## CONCLUSIONS AND SUGGESTIONS AFTER EEP-VCF STAFF VISIT AT THE MISKOLC ZOO (HUNGARY)

Following the proposal from Miskolc zoo to participate in the Bearded Vulture EEP network, it was accorded between Miskolc zoo and EEP/VCF to invite Alex Llopis (EEP coordinator & VCF staff) to visit the Zoo, and have a look for the possibilities to house a pair of bearded vultures in one of their raptors facilities.

Picture 1-2. Plan of the raptor unit, composed by three aviaries.

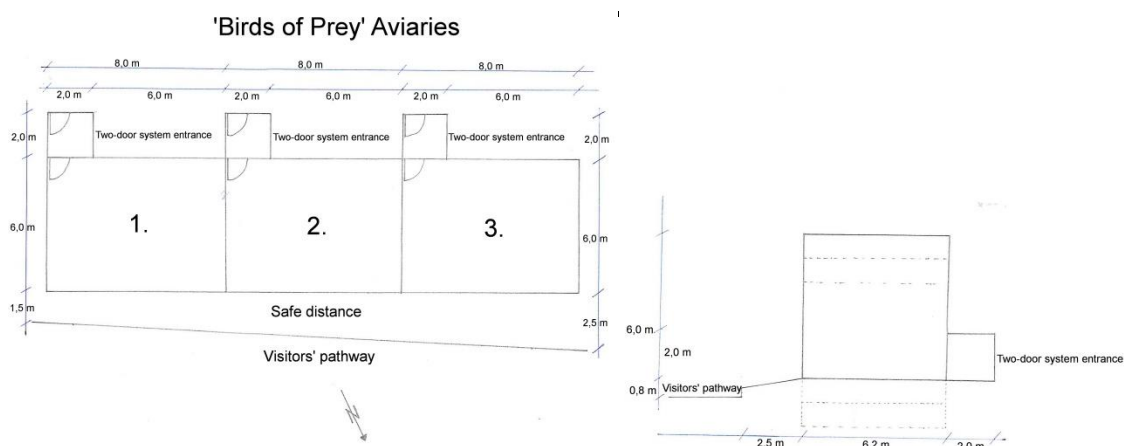
The proposal is to unify the 2<sup>nd</sup> and 3<sup>rd</sup> aviary, removing the lower six 2 x 2m big panels. This will give an optimal size for housing a breeding pair, big enough for giving the birds the necessary escape distance from the visitors and not too big preventing to obtain a dangerous flight speed. Between both aviaries there is a 1,5m high artificial wall construction. In the 2<sup>nd</sup>

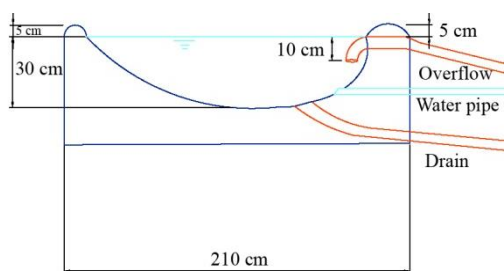
Bearded Vultures as cliff breeders, perches need to be adapted to suit the anatomy of their feet. For assuring to maintain its balance on it is recommended to install **flat perches, around 20cm wide, 5cm thick** and also need to be **rigid enough** to prevent them from bending during copulation on the perch. It is recommended to install a **holding arm perches system which avoids collisions** with it (see white arrow).
